Ref 10.151I13v03

21 July 2016

Re: Amended Access Arrangement and Internal Road relating to 110-114 Herring Road, Macquarie Park – Design Review Statement

Current Podium Plan

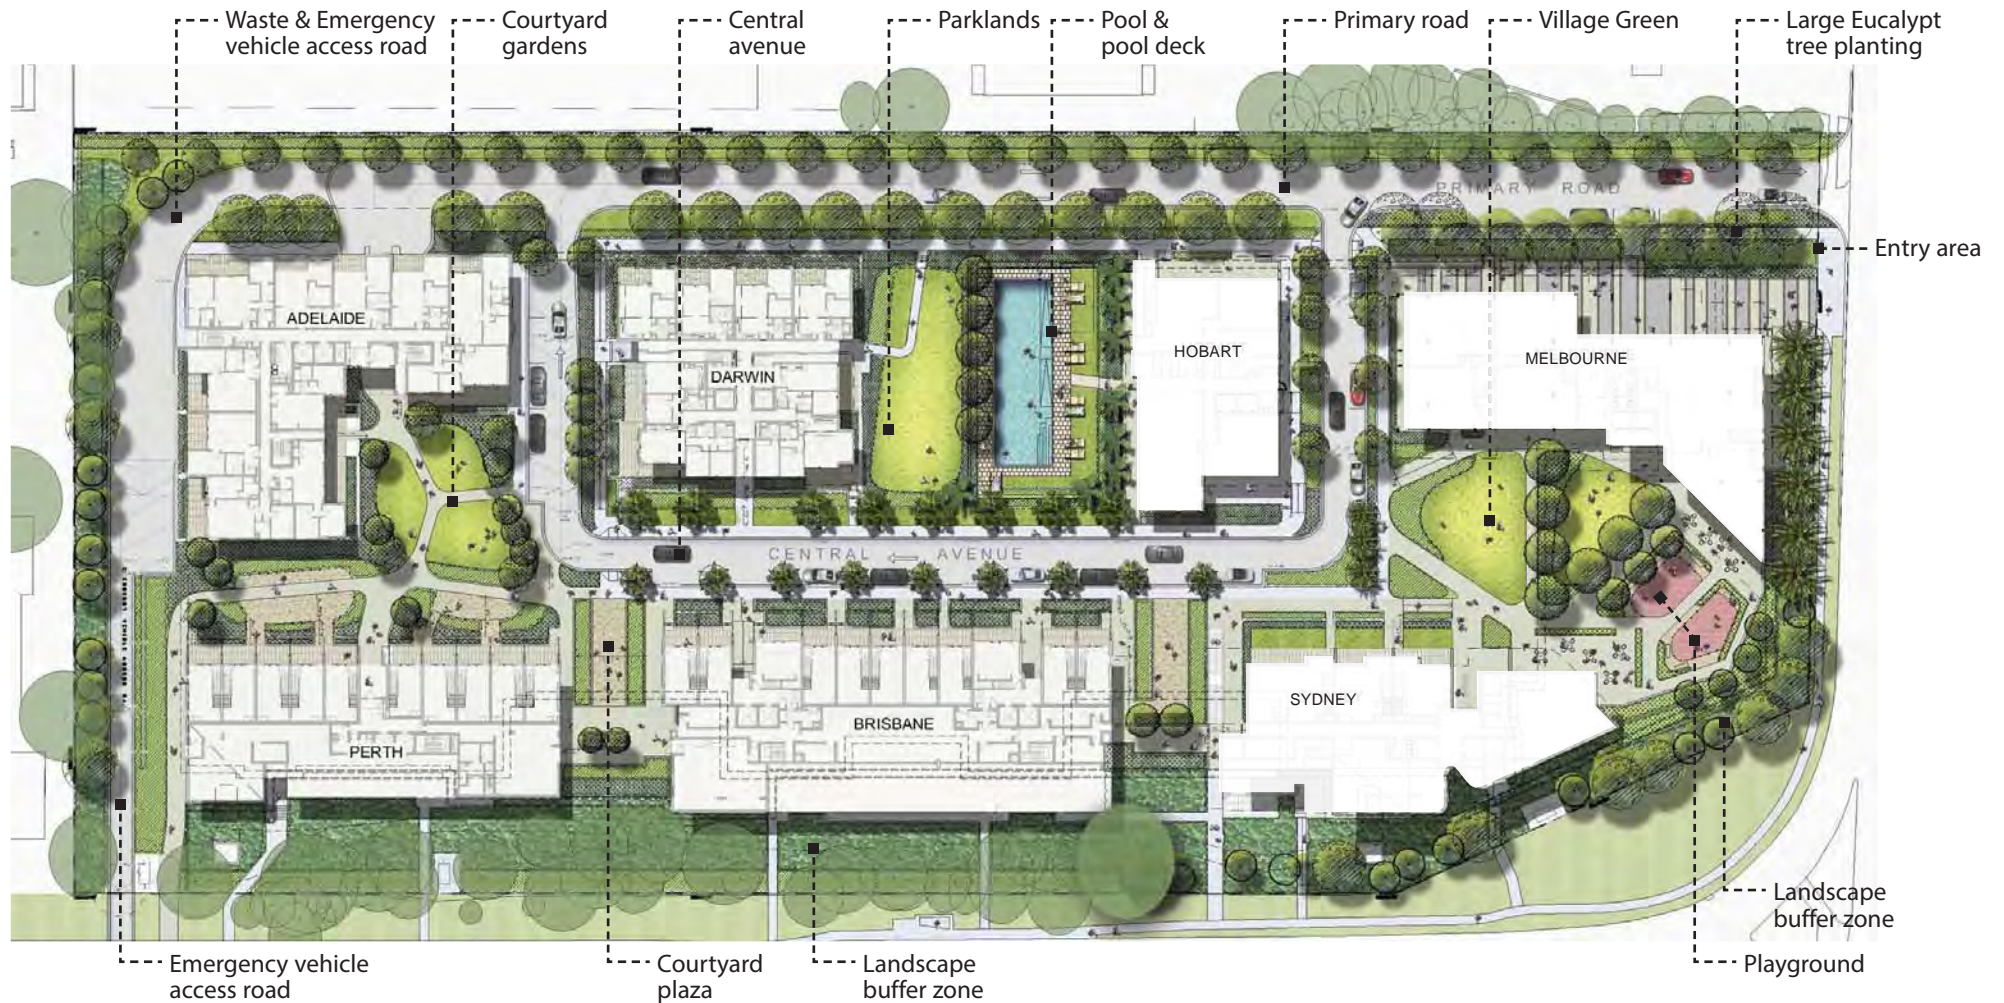
The current arrangement and the proposed arrangement can be viewed in **Attachments A and B** respectively.

Proposed Design

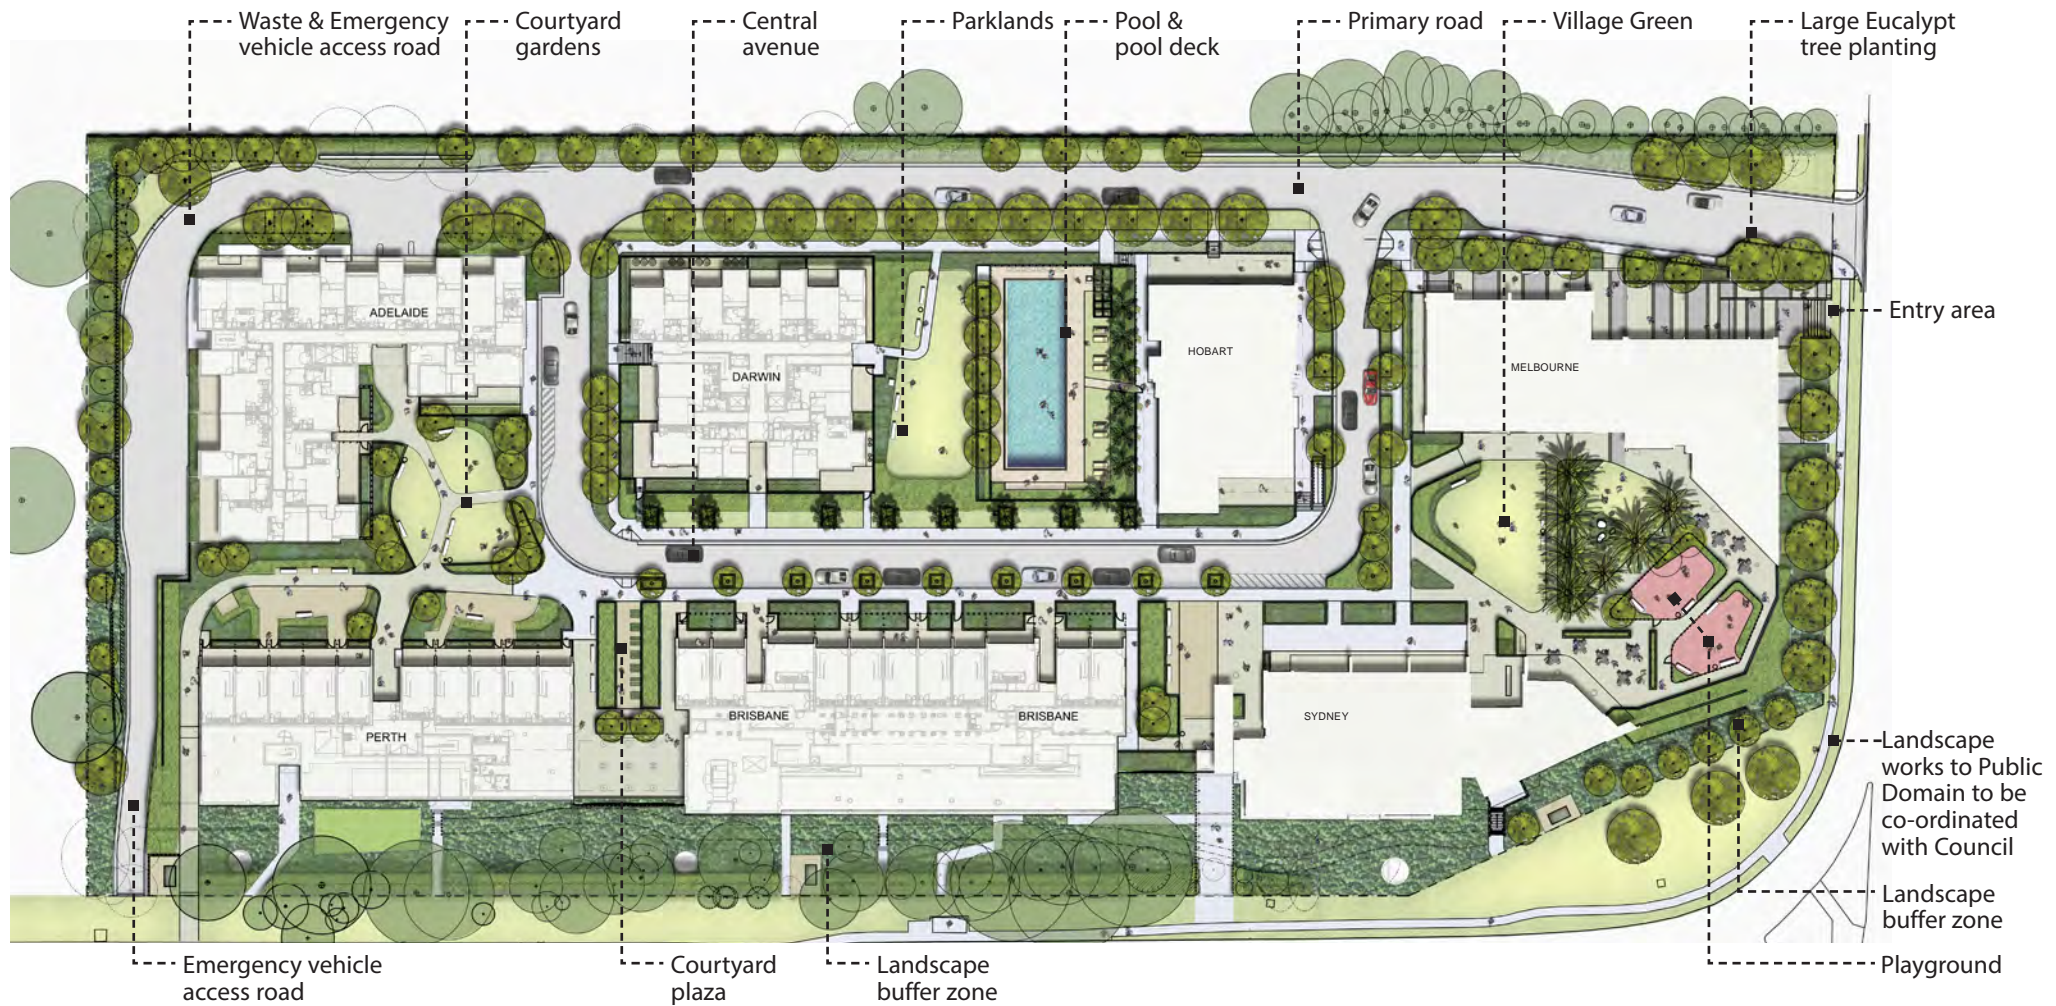
The proposed design for the realigned access driveway involves shifting of the current approved footpath crossover by five metres to the south. The design retains the gradients of the previous access arrangement whilst increasing the width from 6m to 7.5m to assist with vehicles negotiating the resulting deflection on the internal road.

In accordance with the wishes of the NSW Fire Brigade full access is to be made available to all podium areas of the development by a 12.4m long 'Aerial Appliance' emergency vehicle. In order to accommodate this vehicle the kerb lines of the internal road have been revised.

The change to the kerb arrangement results in the loss of 5 podium level vehicle spaces, leaving a total of 14 spaces.

The basement parking provision is to remain as approved whilst the retention of 14 car spaces at podium level ensures the minimum requirement of seven visitor spaces and six car share spaces has been met.

Swept Path Analysis

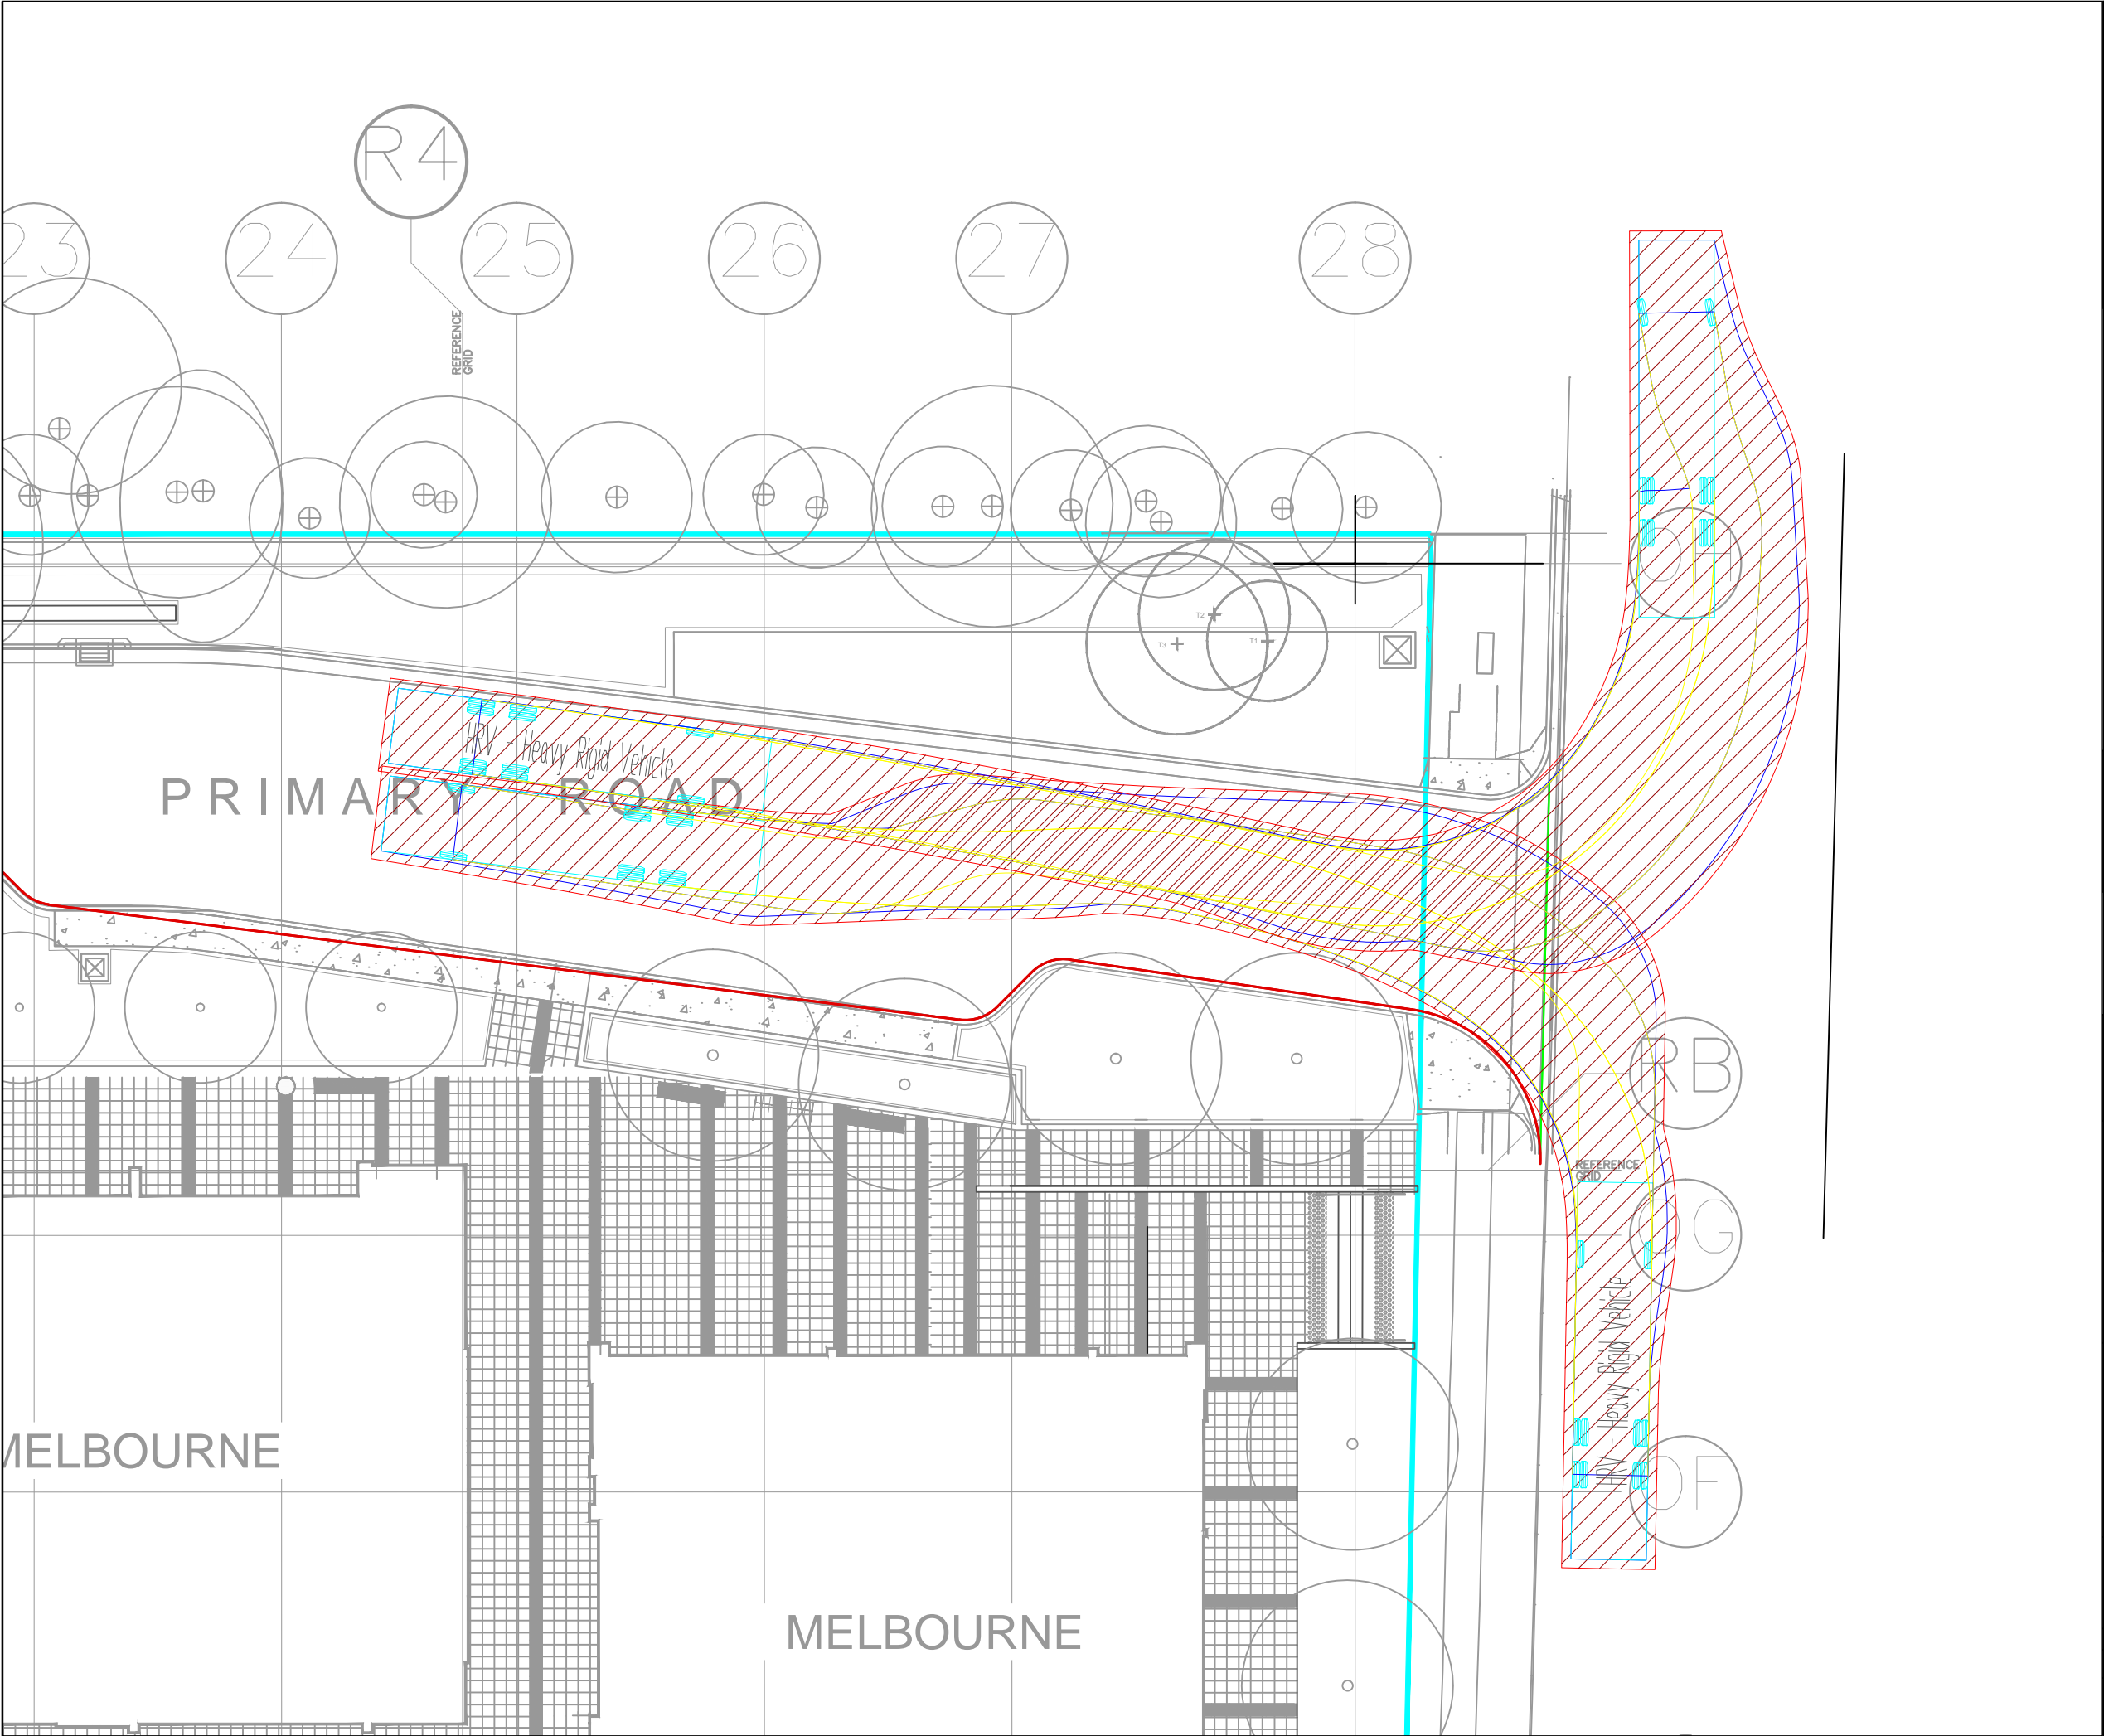
A swept path analysis has been undertaken, as permissible under AS2890.2, to confirm the ability of new design to accommodate the largest design vehicle expected on site (a 12.5m Heavy Rigid Vehicle). The assessment confirms the safe operation of the design, the full assessment is included in **Attachment C**.
